Halton District School Board

Addendum No. 4

RFT 26-030 Oakville #5 Elementary School & Child Care Facility

ADDENDUM NO. 4**Issued February 10, 2026**

QUIET ROOM CURTAIN WALLS - 231, 229, 331, 329

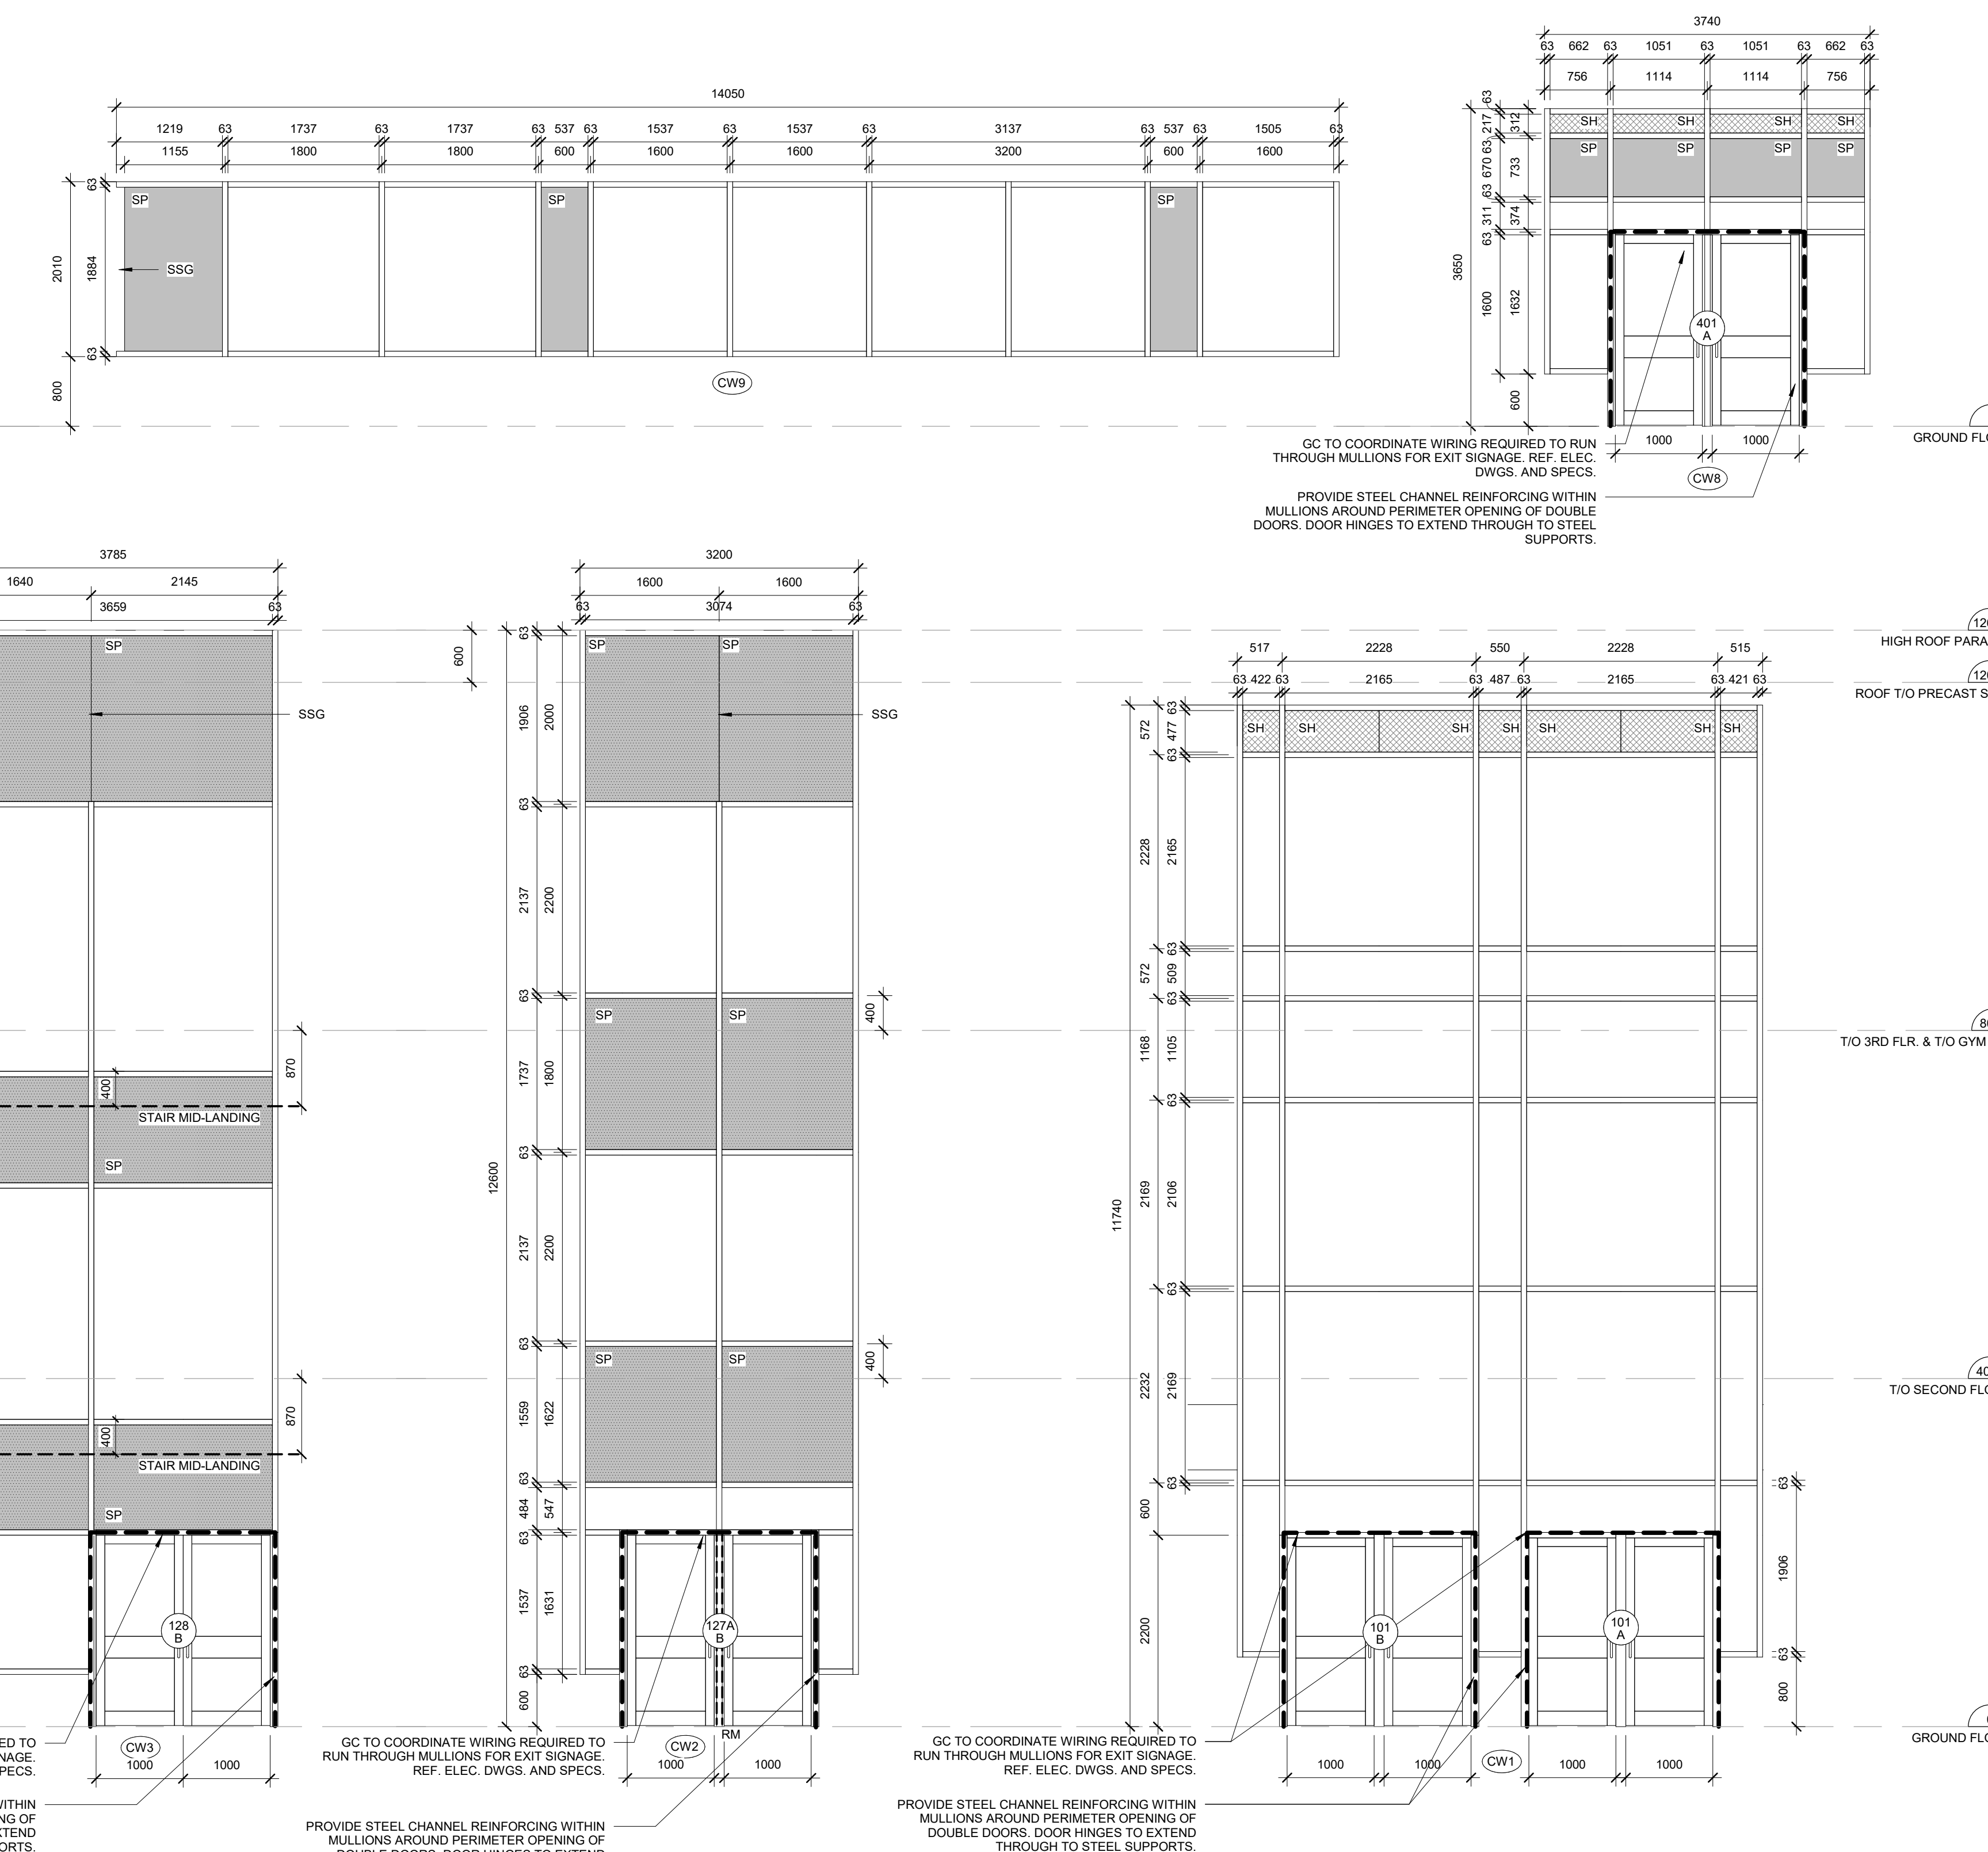
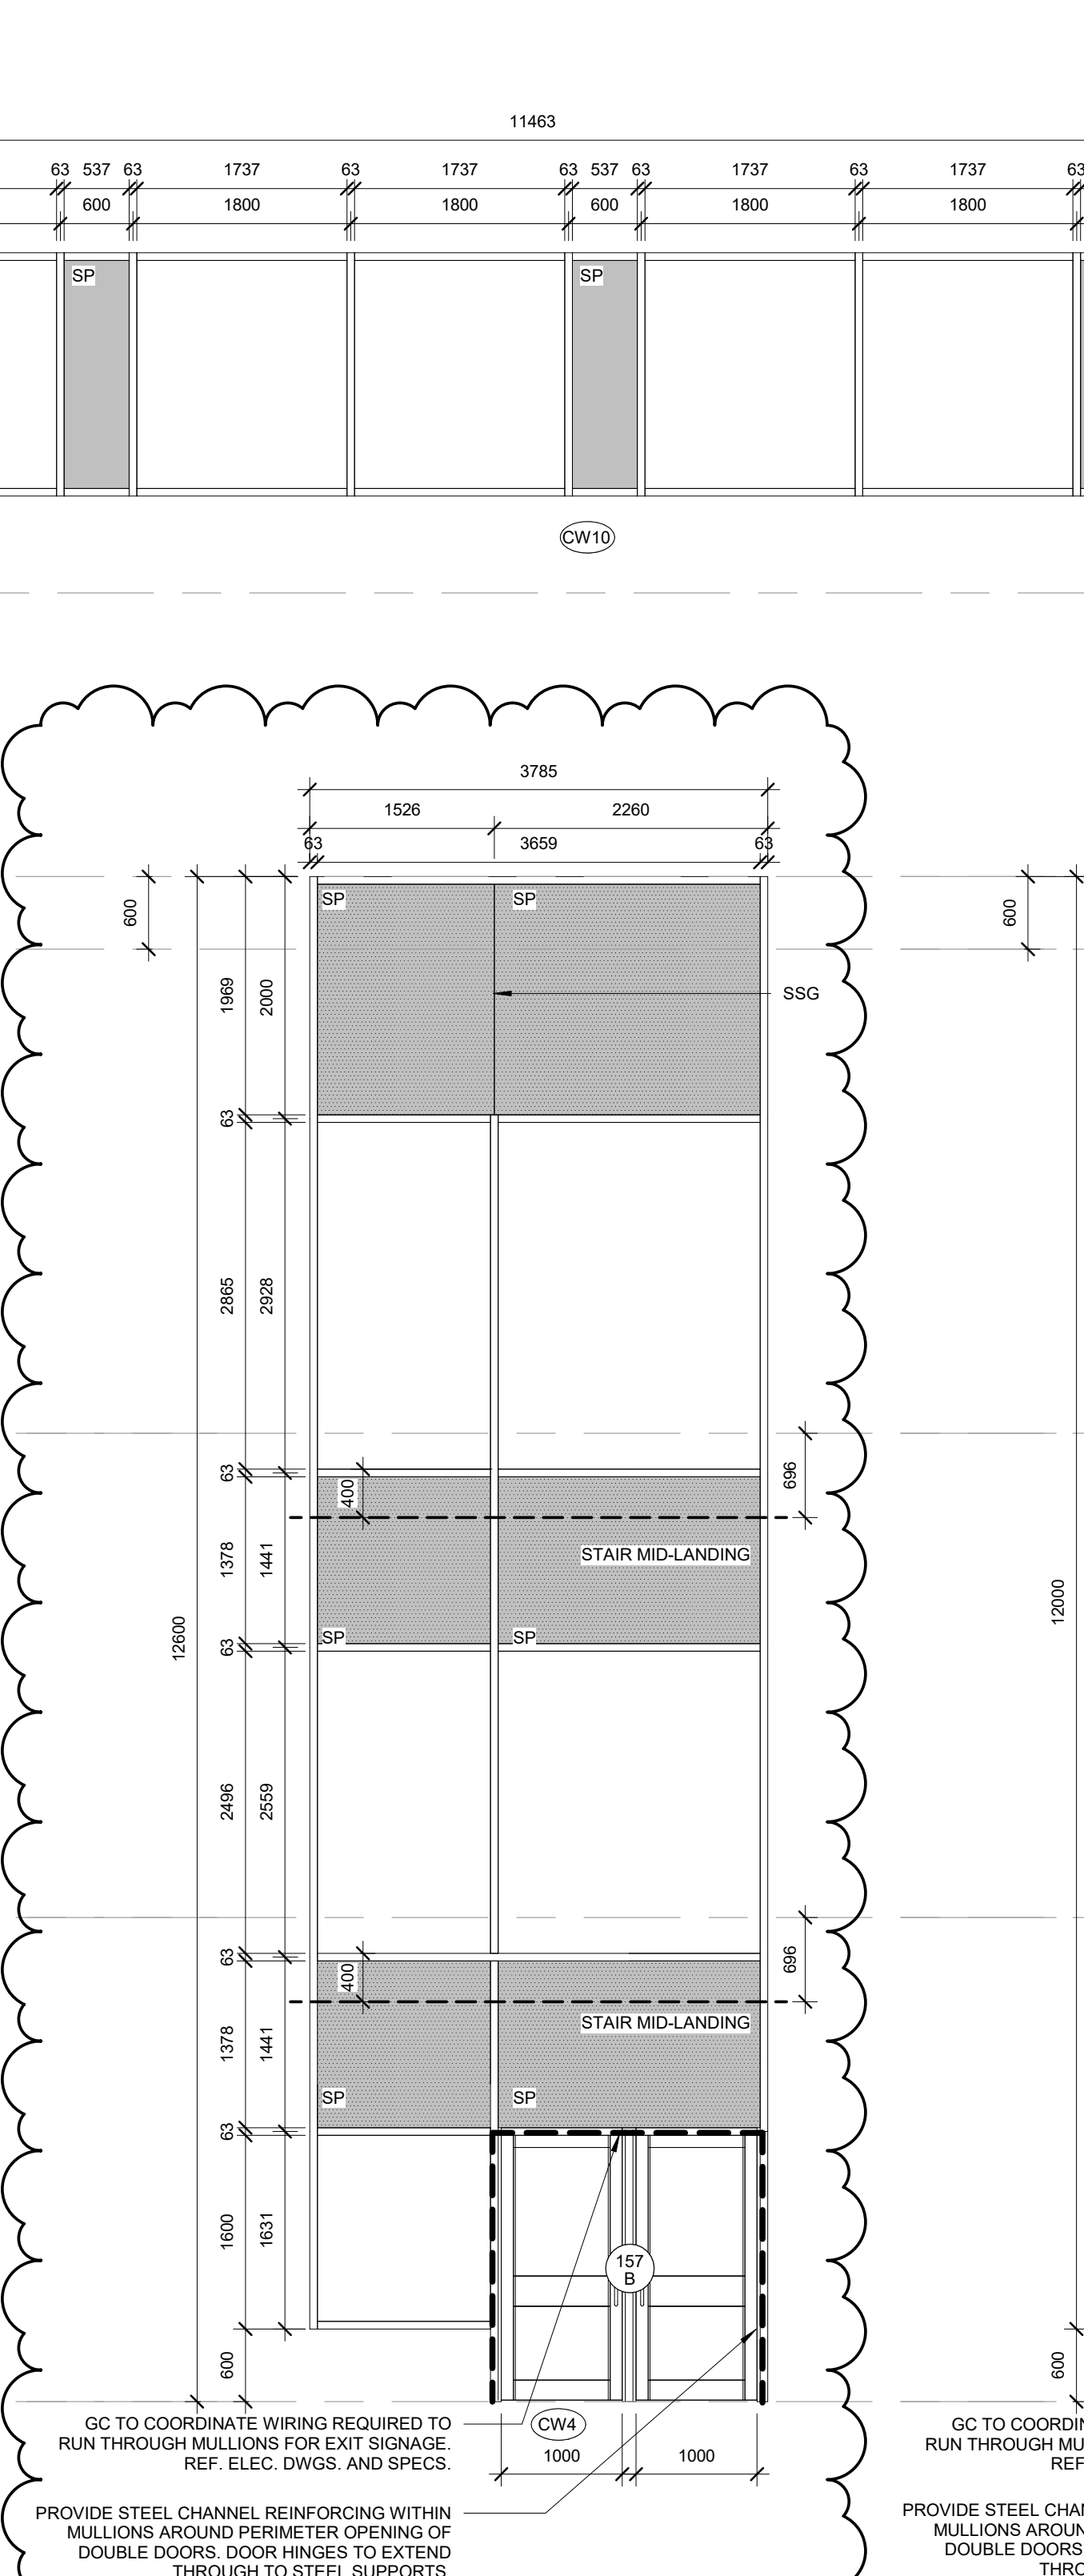
- .1 REVISE: QUIET ROOM 229, 231, 240, 245, 248, 329 and 331 wall finish to read: "BB / POR.WD".
- .2 REVISE: 'QUIET ROOM 229, 231, 240, 245, 248, 329 and 331 remarks to read: "REFER TO CURTAIN WALL SCHEDULE. BB ON ENTIRE WALL REFER TO ARCH. PLANS."
- .3 DELETE references to 'smoke baffles' in '157 Stair A' and '201 Stair A'.
